TOWN OF JACKSON ZONING ORDINANCE

RE-DESIGN FOR EXPIRED DESIGN- ECA2016091215

DESIGN PLAN FOR :

TAX MAP V-4, LOT 8

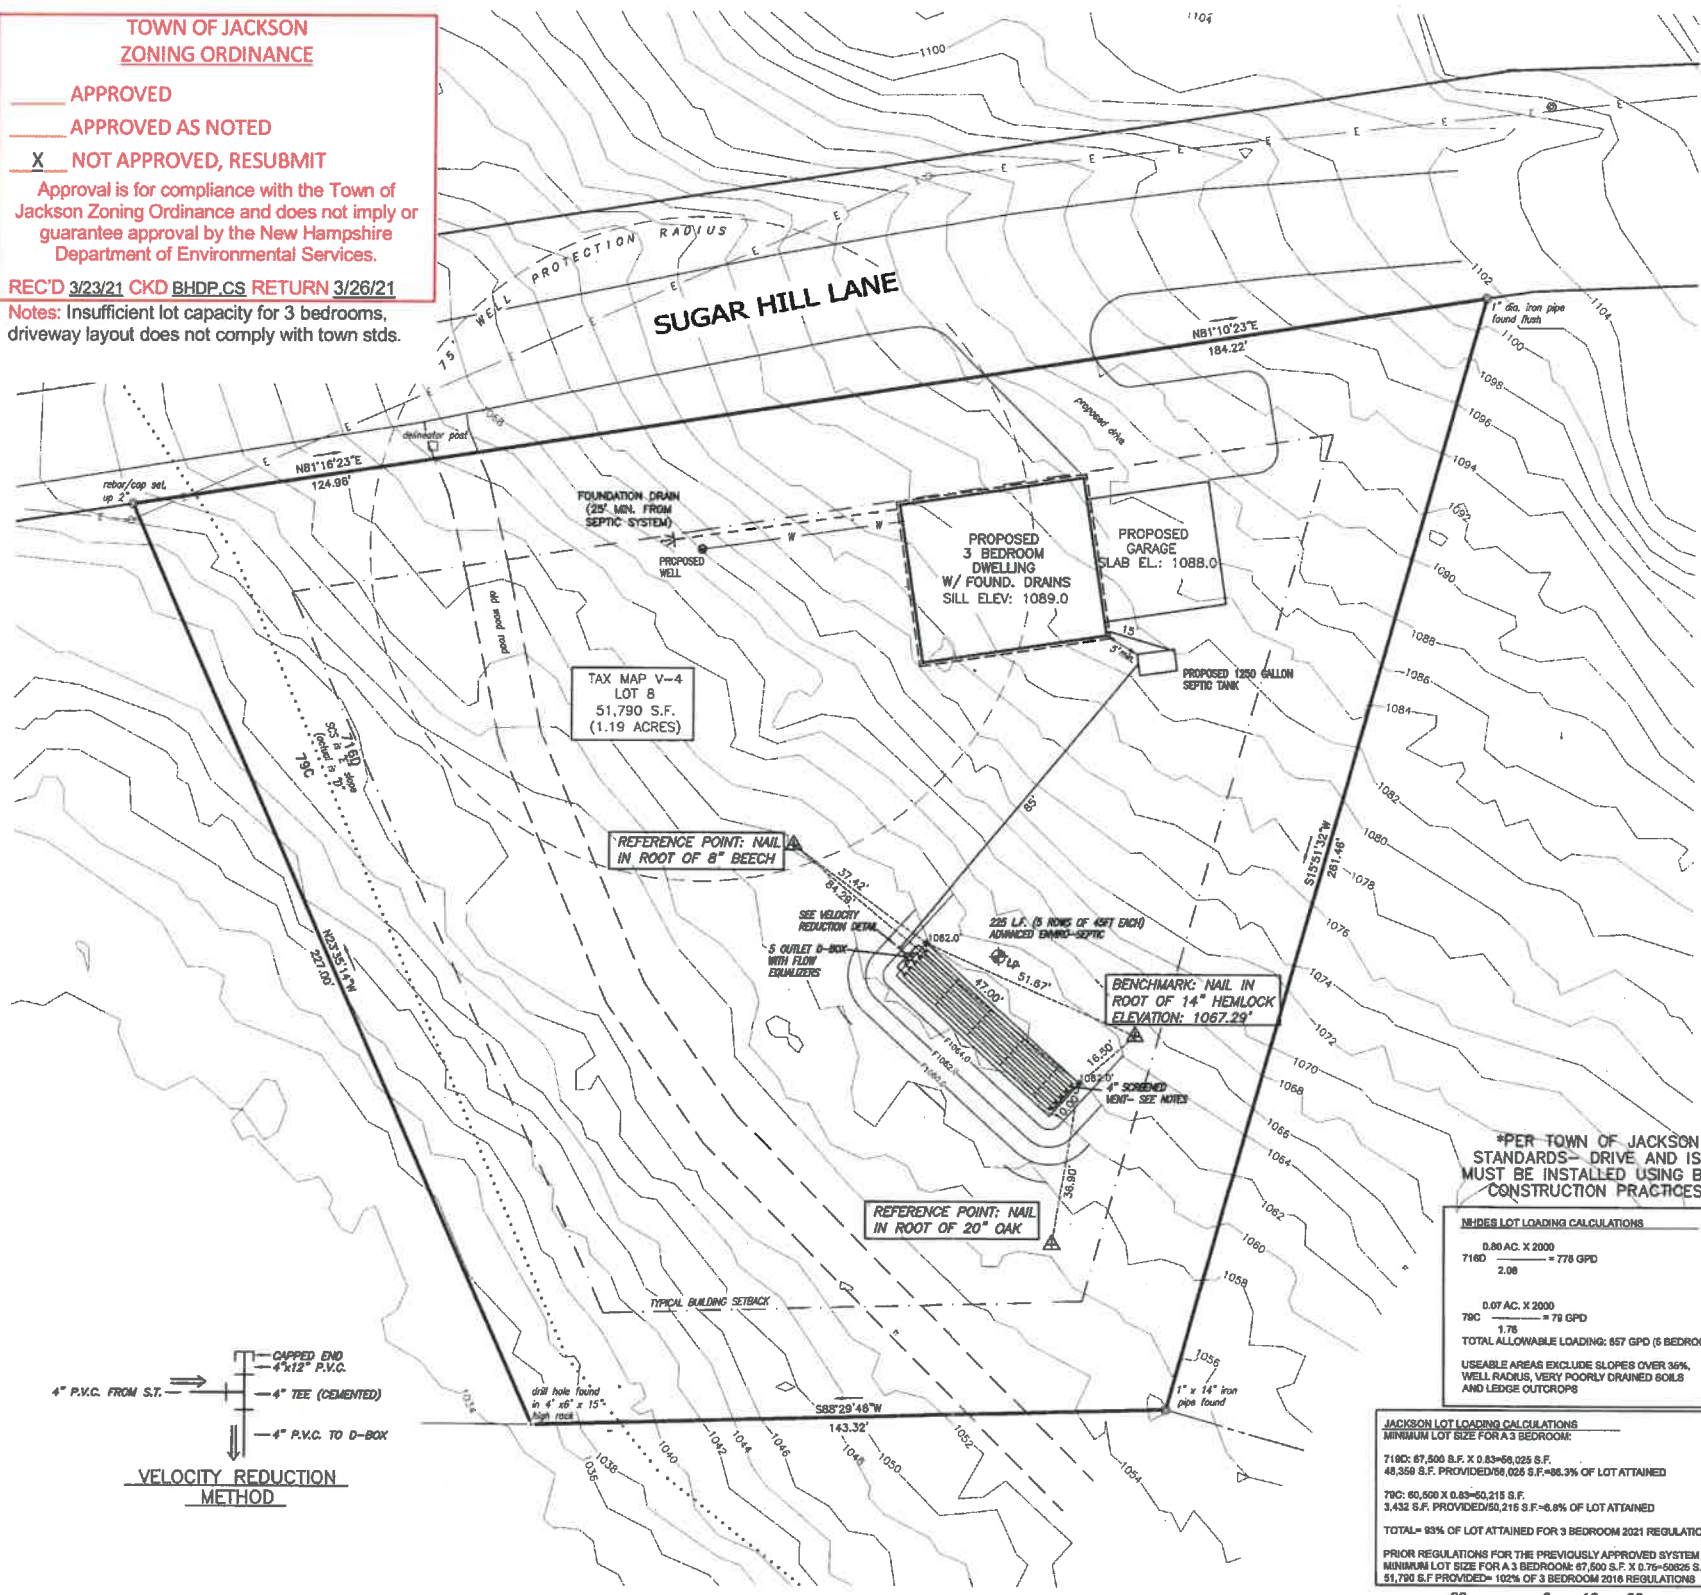
- APPROVED
- APPROVED AS NOTED
- ☒ NOT APPROVED, RESUBMIT

Notes: Insufficient lot capacity for 3 bedrooms, driveway layout does not comply with town stds.
